BHARAT HEAVY ELECTRICALS LIMITED
PROJECT ENGINEERING MANAGEMENT, NOIDA

CORRIGENDUM- 03

PROJECTs	:	2000 TPD BCGCL COAL TO AMMONIUM NITRATE - LSTK 1
PACKAGE	:	INDUCED DRAFT COOLING TOWERS (IDCT)
ENQUIRY NO	:	77/26/6036/AMI dated 13.05.2026
SUBJECT	:	Technical amendment 02 and Replies to pre-bid queries

AMENDMENT NO. - 02

2.0 Following drawings / documents / details are added in Specification.

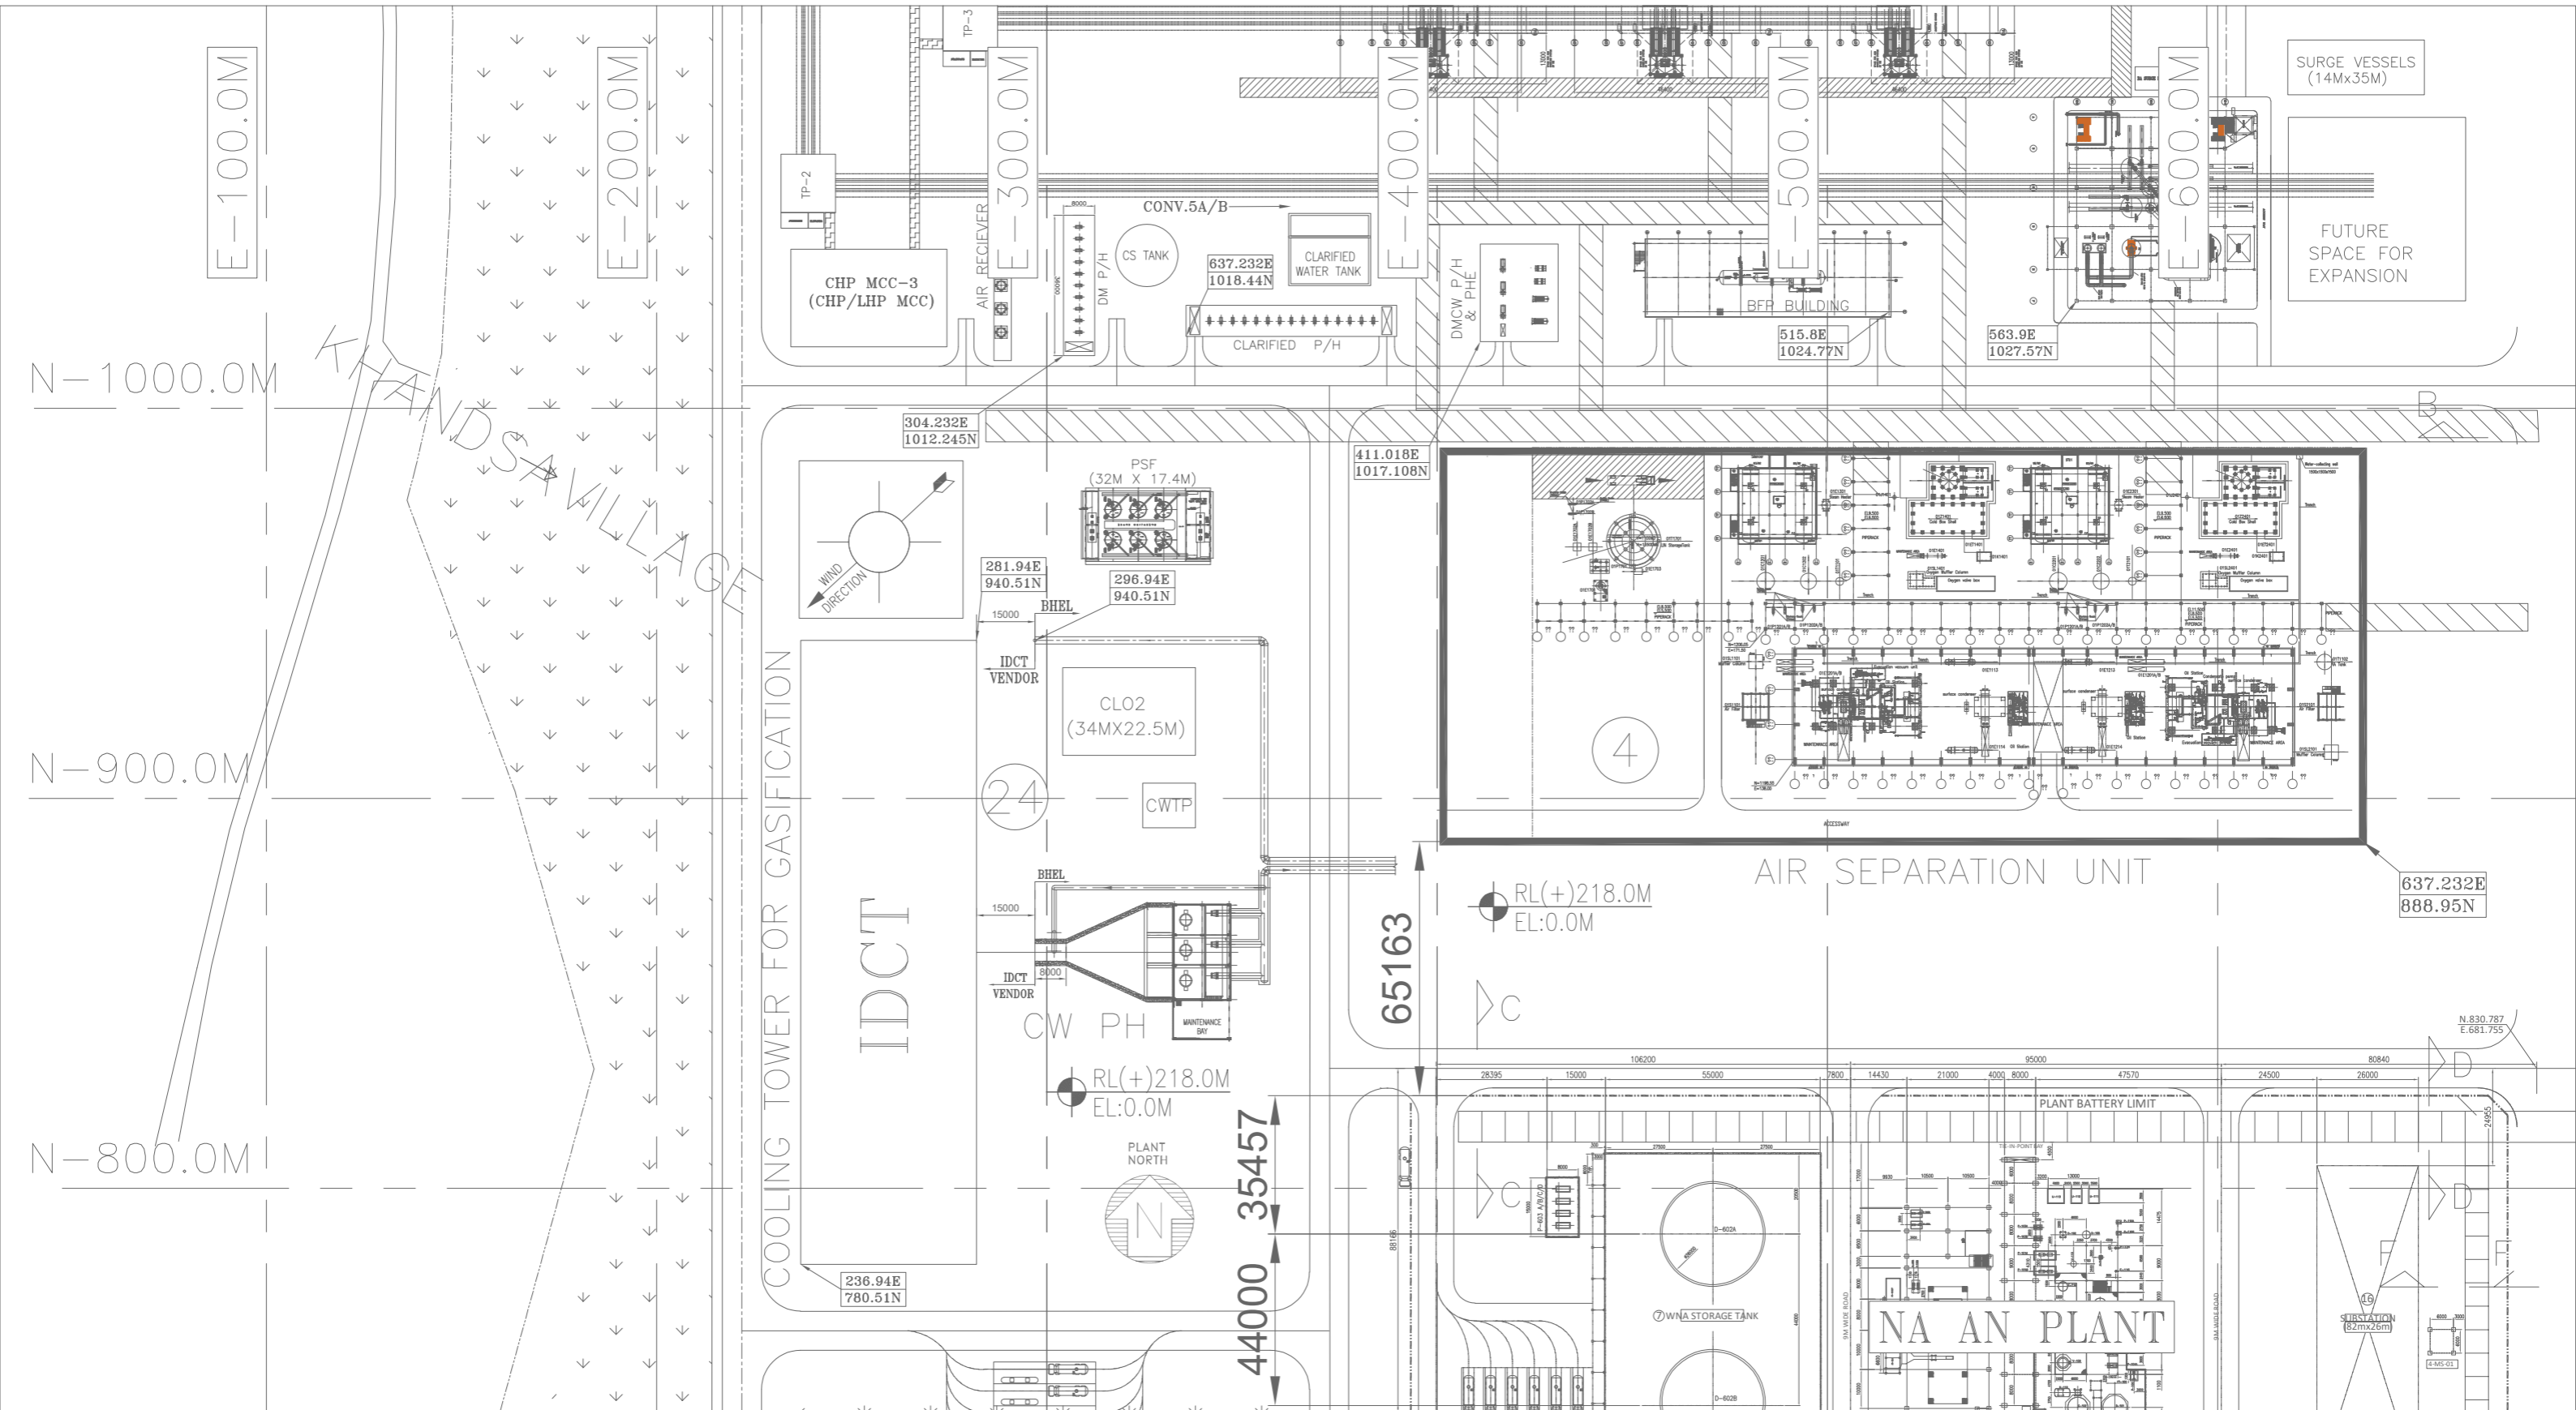
SI No	Reference			Queries	BHEL REPLY
	Section	Chapter / Cl. No	Page No.		
TECHNICAL					
1	Technical Specification for IDCT (Part-2 / Book-1)	Annexure-3 / IDCT Key plan and Terminal Point Details	4 / 216	<p>It is noted from the key plan that the terminal point of the hot water return header is on the same side with the supply header at the sump side of the IDCT. Hence the downstream routing of the hot water distribution header from this terminal point alongside the Cooling tower will be more complex, since this header needs to be routed further underground to avoid clash with basin/channel and its foundation. This will significantly increase the no. of bends and fittings in the distribution piping network, which will, in turn, increase the pressure loss of the entire hot water return line.</p> <p>Considering the above constraint, please provide the hot water return header terminal point opposite the sump side of the IDCT, i.e. at the north-west or south-west direction of the IDCT by the road side. This will lead to better distribution of the hot water flow through the uniform piping network ensuring minimum pressure loss along the IDCT.</p>	Revised key plan attached as per Amendment-02

CI no.	Clause as mentioned in Technical Specification	Amended Clause
ANNEXURE-1 : Circulating water analysis (with COC 5), page 2 of 216 of TECHNICAL_SPECIFICATION_BOOK_1_OF_2_(PART-2)	ANNEXURE-1 : Circulating water analysis (with COC 5)	ANNEXURE-1 : Revised Circulating water analysis (with COC 5) is enclosed.
ANNEXURE-3 : IDCT KEY PLAN AND TERMINAL POINT DETAILS , page 4 of 216 of TECHNICAL_SPECIFICATION_BOOK_1_OF_2_(PART-2)	ANNEXURE-3 : IDCT KEY PLAN AND TERMINAL POINT DETAILS	ANNEXURE-3 : Revised IDCT KEY PLAN AND TERMINAL POINT DETAILS is enclosed.
